RIDGWAY PLANNING COMMISSION

AGENDA

Tuesday, September 25th, 2018
Regular Meeting; 5:30 pm
Ridgway Community Center
201 North Railroad Street, Ridgway, Colorado

Subject: Preliminary Plat Submittal
Legal: Ridgway Land Company Subdivision Lots 30-34
Address: TBD Redcliff Drive
Parcel #s: 430516402012, 430516402011, 430516402010, 430516402009, 430516402008
Zone: General Commercial
Applicant: Joseph Nelson
Owners: Ridgway Land Co. / Rob Hunter
Initiated By: Shay Coburn, Planner
Date: September 25, 2018

OFFICE (970) 249-5349 - FAX (970) 626-6261
CELL (970) 729-1289
1147 OURAY COUNTY ROAD 22 - MONTROSE, COLORADO 81403
565 SHERMAN STREET, SUITE 10, RIDGWAY, COLORADO 81432
WWW.ORIONSURVEYING.COM

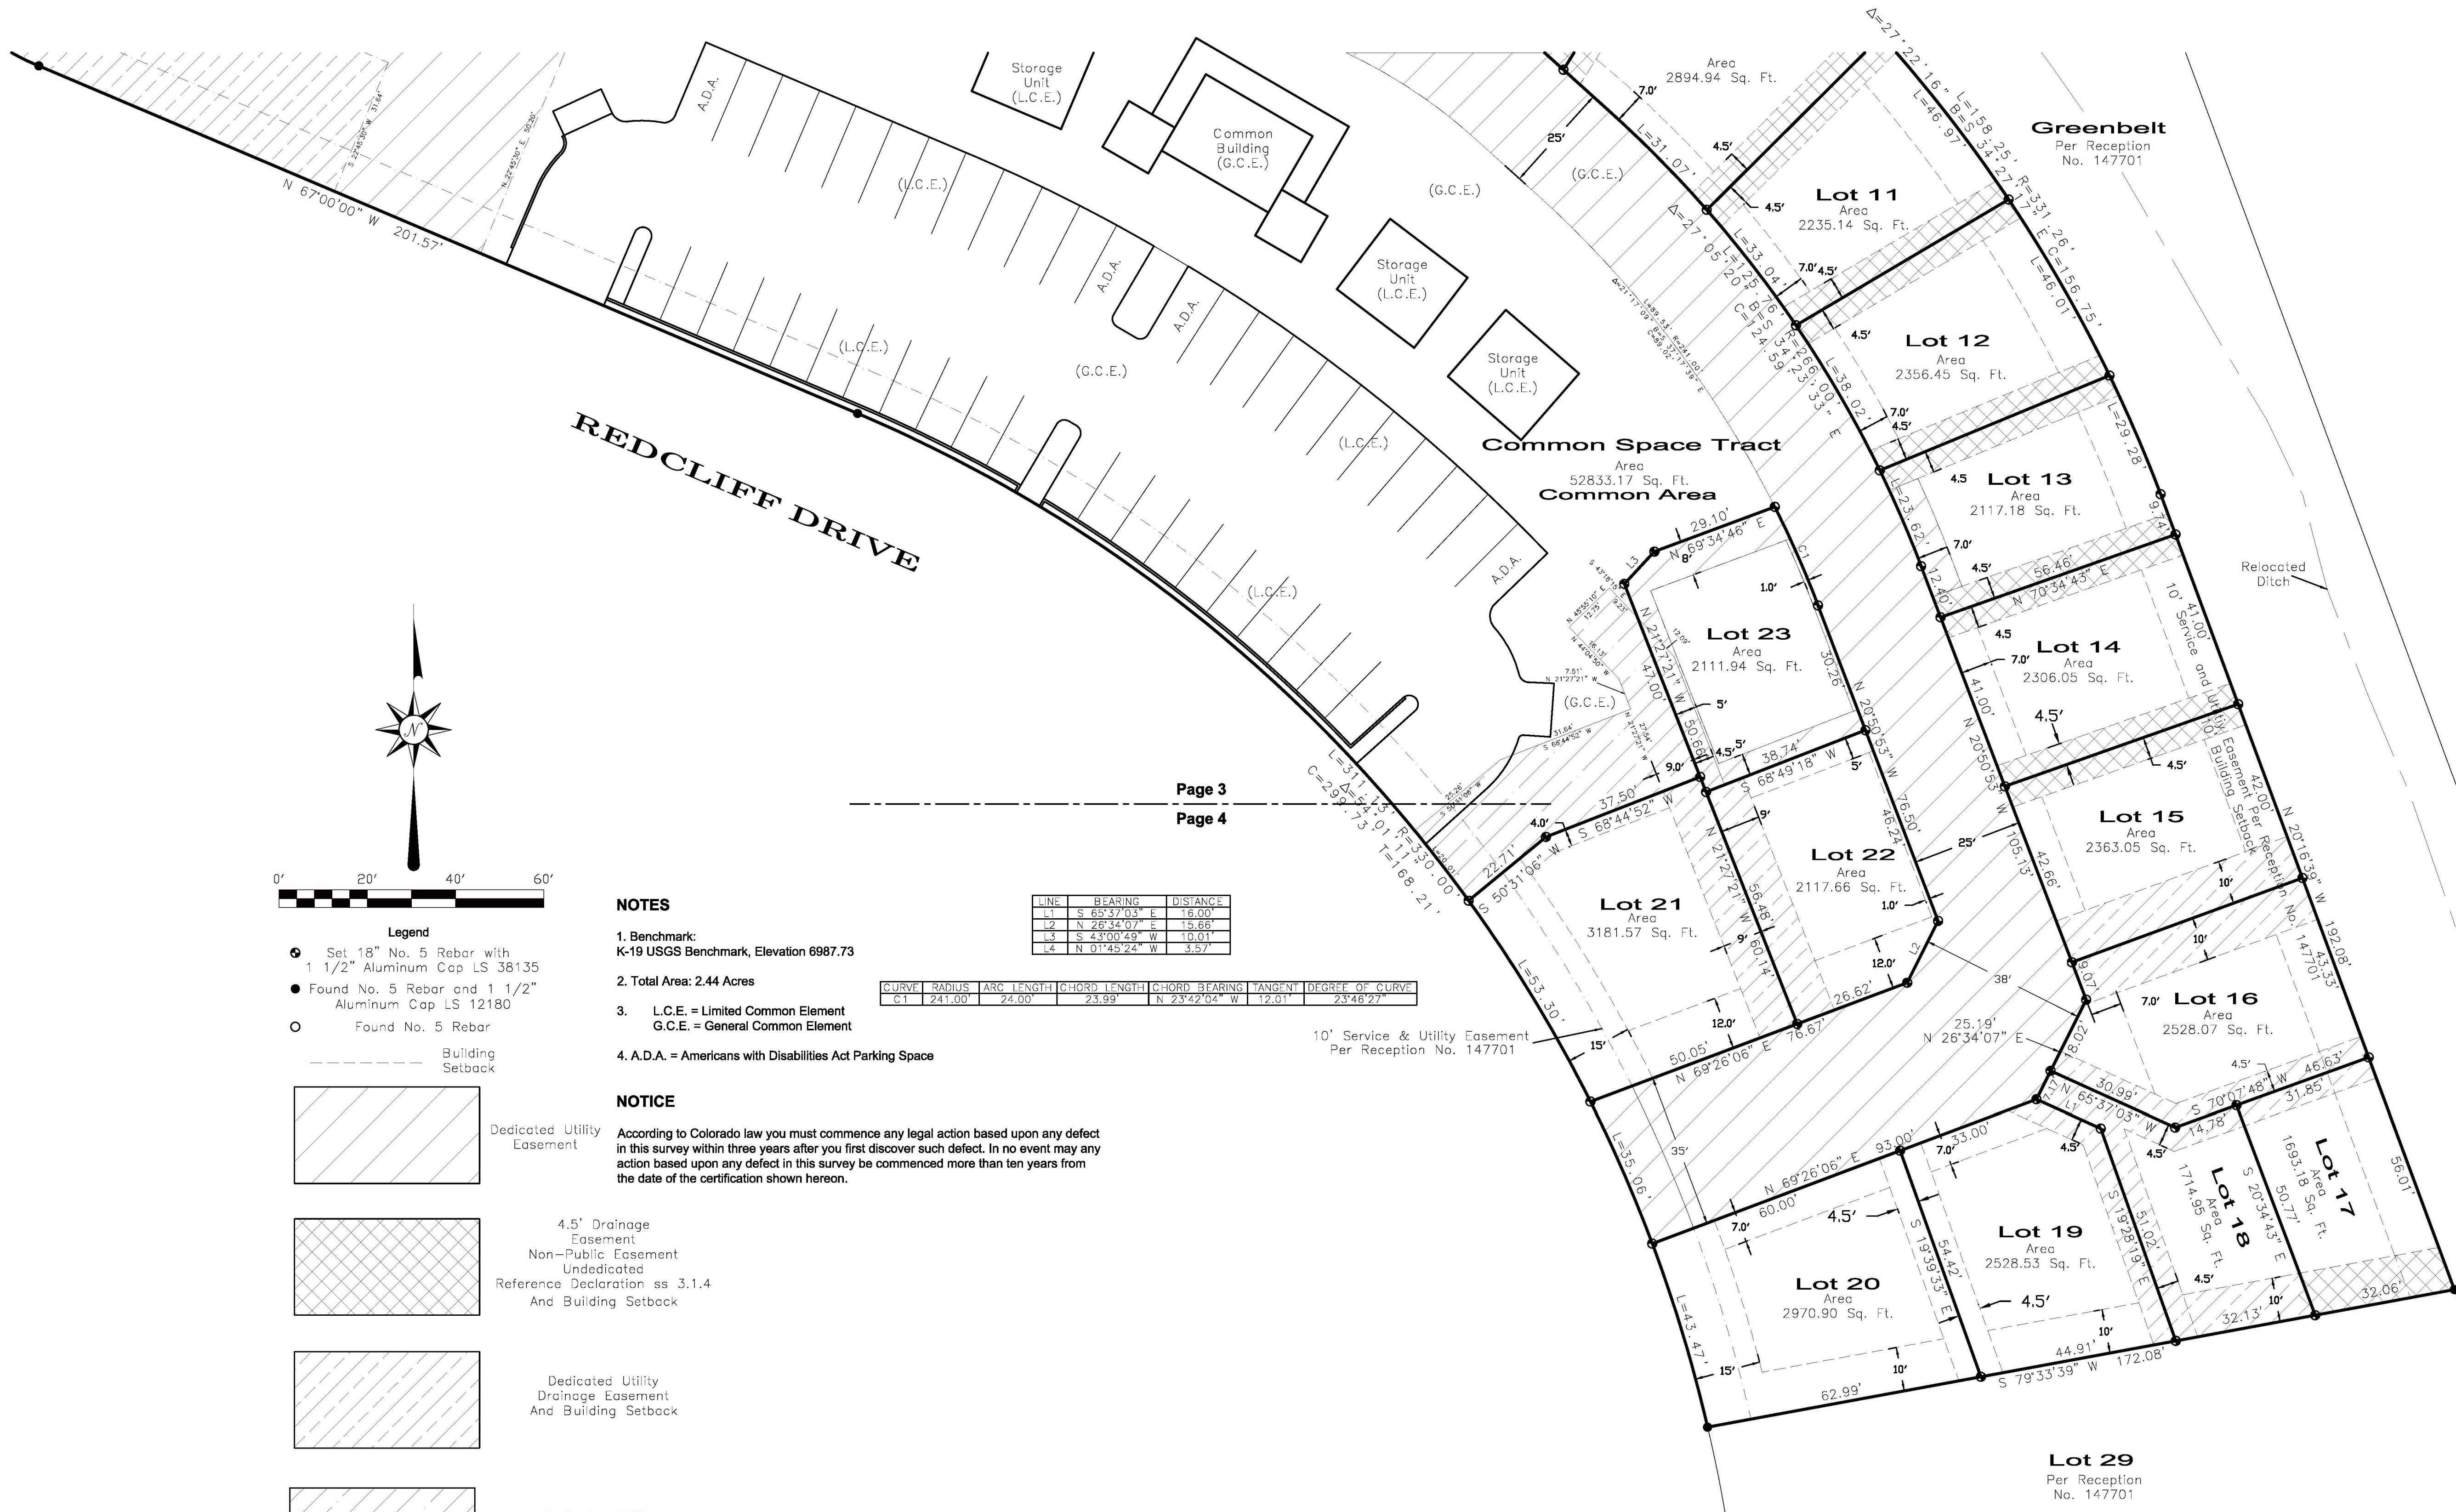
- The plat map is missing a stamp from the surveyor. *Will need a stamp once the plans are approved by the Planning Commission and/or Town Council.*
- The basis of bearing on the plat map needs to be labeled on page 2. All basis of bearing text should reference the “Ridgway Land Company Subdivision” not the “Ridgway Land Company Triangle Subdivision.” *Page 2 still needs to be corrected.*

- Page 4 is missing the drainage easement on the top of the map. Add or combine pages as suggested above. [Complete.](#)
- Declarations should only be referenced once where the recording number will be filled in. See notes 2 and 9 for examples where reference should be removed. This constant cross references will cause confusion in the future when the declarations are edited, likely bringing up the need for a plat amendment. Reference the plat map as an exhibit to the declarations. [Applicant stated: The reason for the cross reference is that the rights and privileges to the LCE are subject to further refinement in the Declarations. Without this, the rights and privileges to the LCE per the Plat appear unrestricted, and they are not. See Art 4 of Decs. The same is true with respect to maintenance of the LCE and GCE in the there are many refinements to the maintenance obligations as between the HOA and the Unit Owners. Without this reference, the Plat appears make this the sole obligation of the HOA. See Art 7 of the Decs. My understanding is that both the Plat and the Decs are to be approved by the Town Council, and any future change in either document will require the same amendment procedure. Town response: The decs are reviewed by the Town to be sure they do not involve the Town and to avoid any foreseen issues. The Town does not review any future changes to the decs unless required by the decs, which is not a good idea. Things that Town enforces should be on the plat, things that the HOA enforces shouldn't be on the plat, just reference the declaration and the reception number. All other cross references shall be removed as asked for above. If the applicant wants, they can add language to reference of the private declarations like – “Notice for all potential buyers and owners: you are advised to read the private declarations in their entirety”. Any cross references to the decs in the dedication language also needs to be removed. If an easement is dedicated to the town, we don't want to find further restrictions or allow the HOA to further restrict in the future through an amendment to the declarations.](#)

Need to show the location of the relocated ditch on pages 3 and 4 of the plat. Ensure it matches the civil plans. *While there are no dimensions, bearings, distances, etc. it appears to match and was added to the plat map.*

- Easement measurements between buildings are not consistent between the preliminary plat map and the other site plan provided, especially on the southern side of the property. Please reconcile. *U-1 and pages 3-4 on the plat still don't match – between lots 16, 17, 18, 19, 22, and 23. Why was a utility easement added to lot 23 just on page 4?*

Lots along Redcliff Drive appear to have two building setback lines. Use a different line type to depict easement boundaries. *If lines were changed, they are not different enough to tell (or just don't print well).* Also, please add the easement line type to the legend.

SITE PLAN

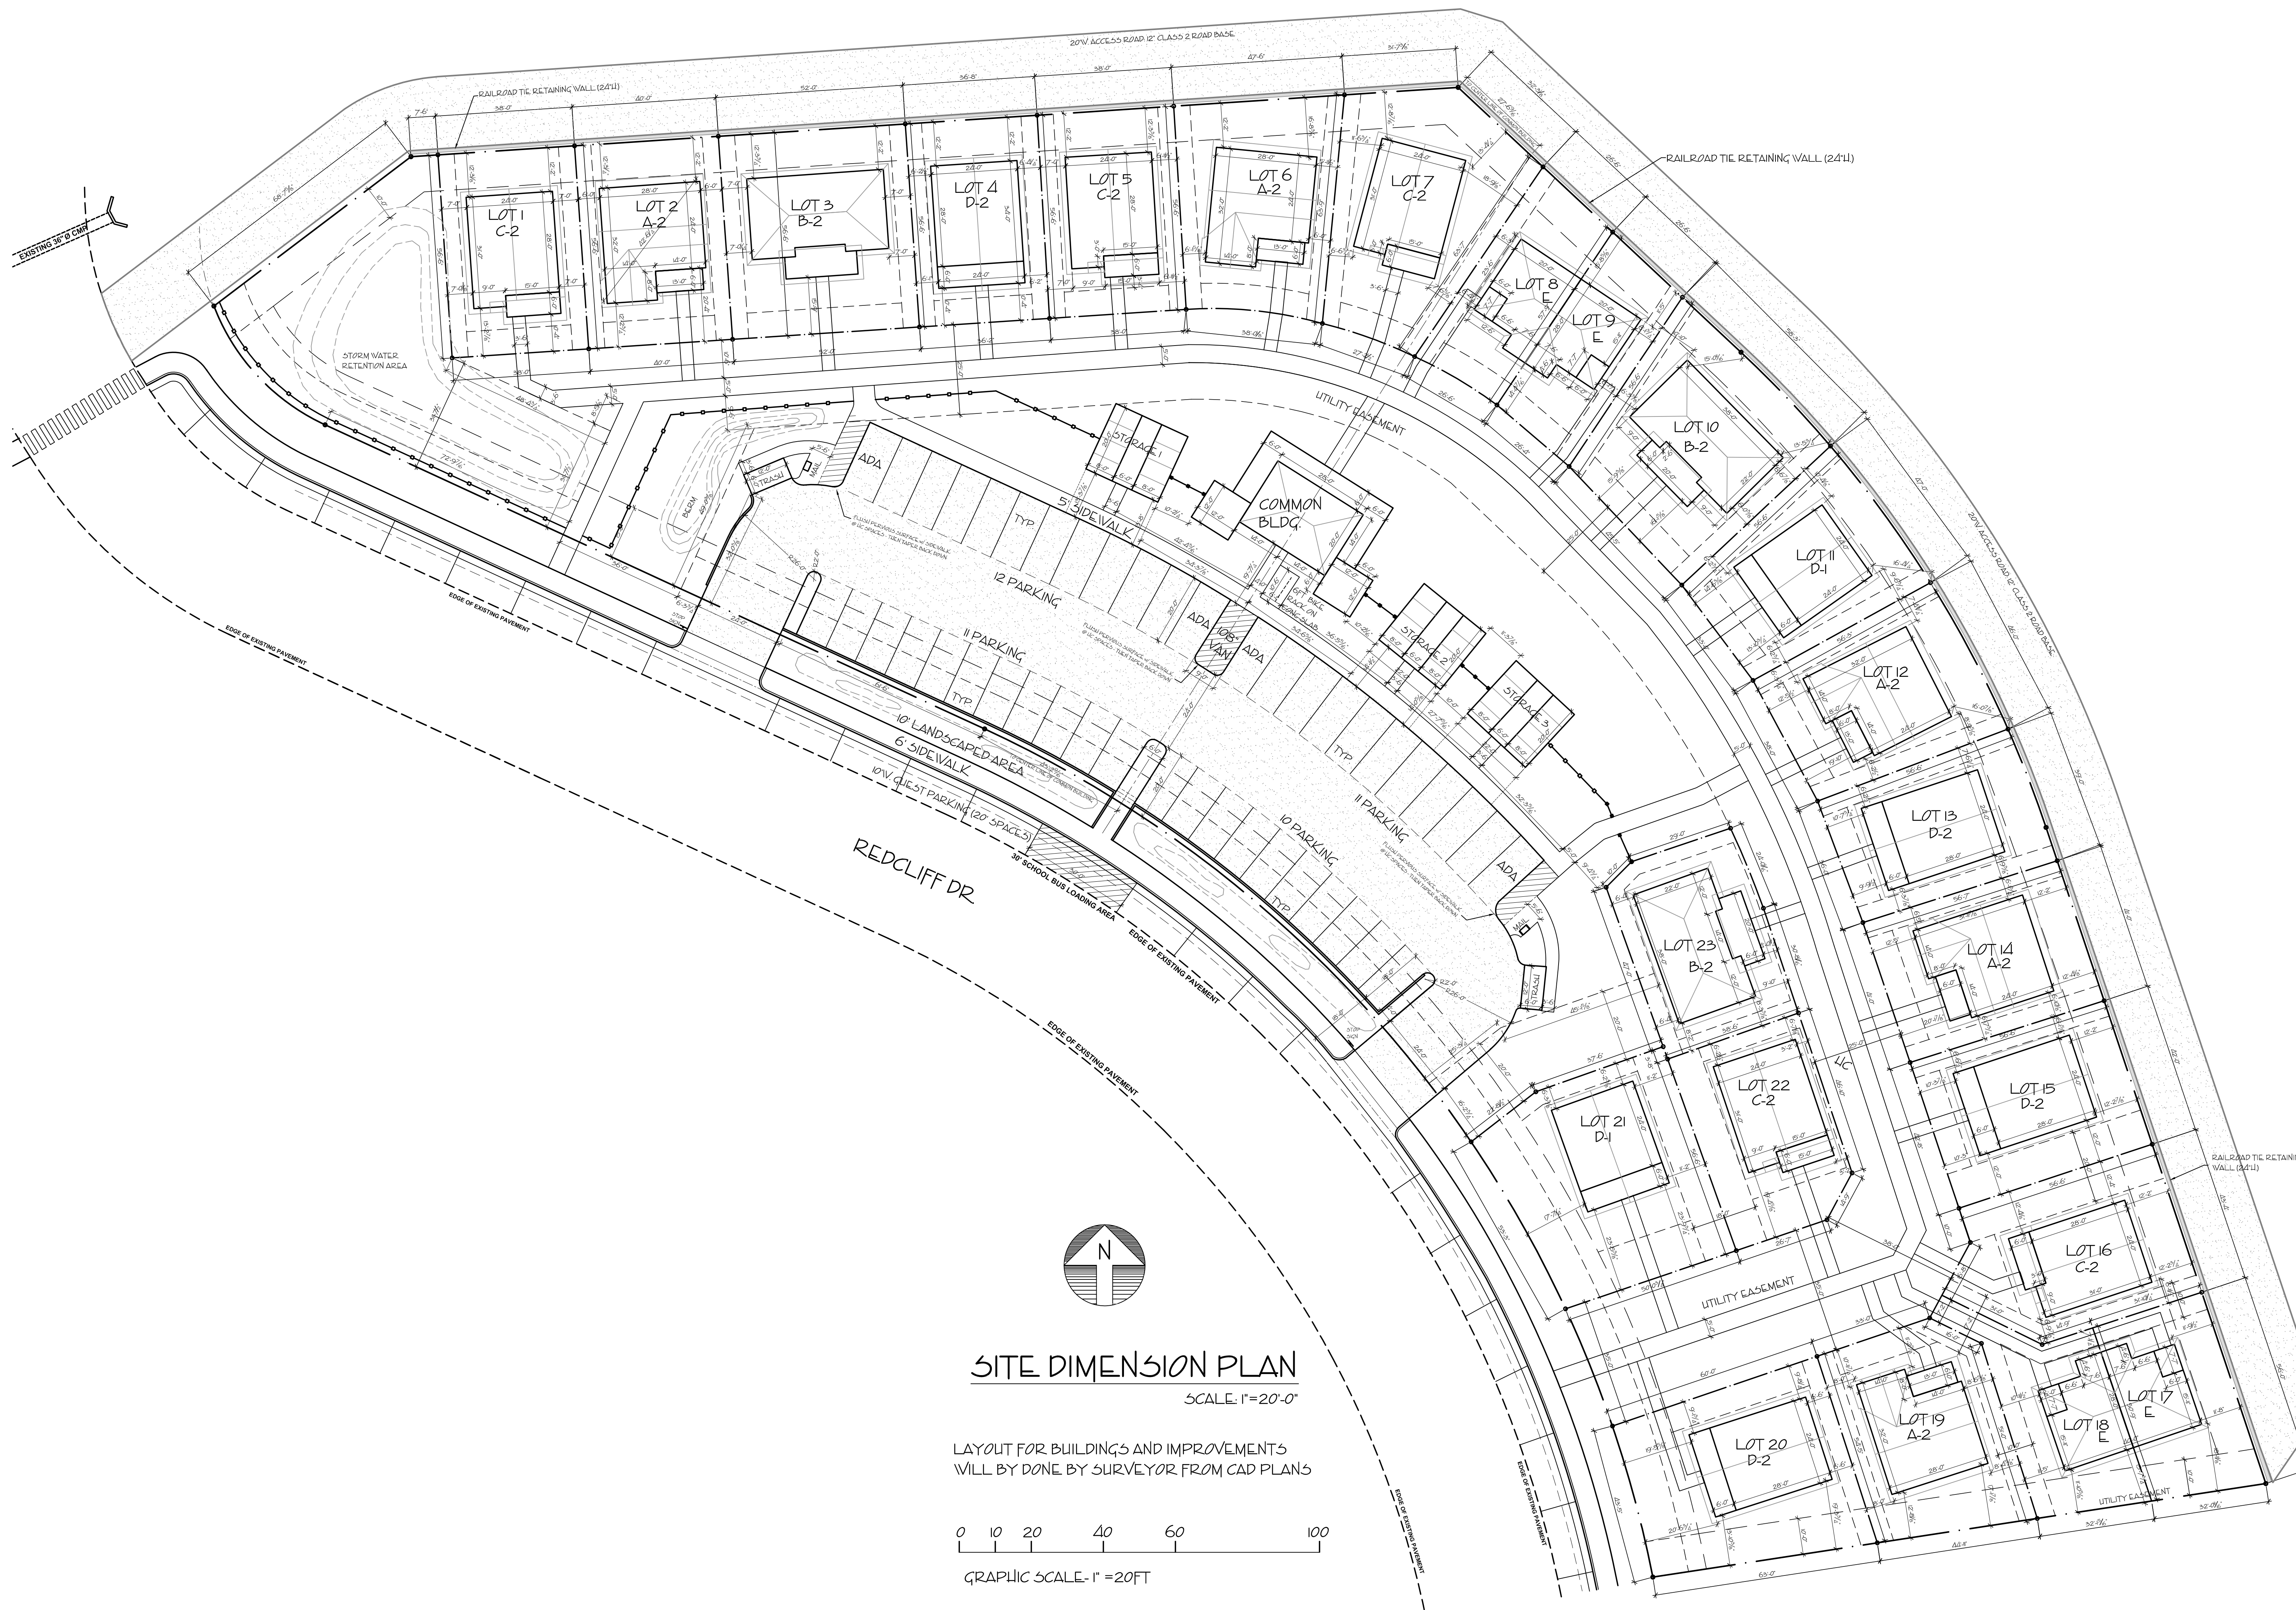
- Delete E-1 from schedule of drawings on S-1. [Done.](#)
- Change title of the second S-1 sheet to S-2 (the one with the measurement). On S-2 add measurements to be able to locate utilities as well. [Changed to S1.1 which works just fine. Doug added N-E bearings at manholes and dimensions on U-1 for min. clearances. Please add bearings for the water fittings and power peds.](#)
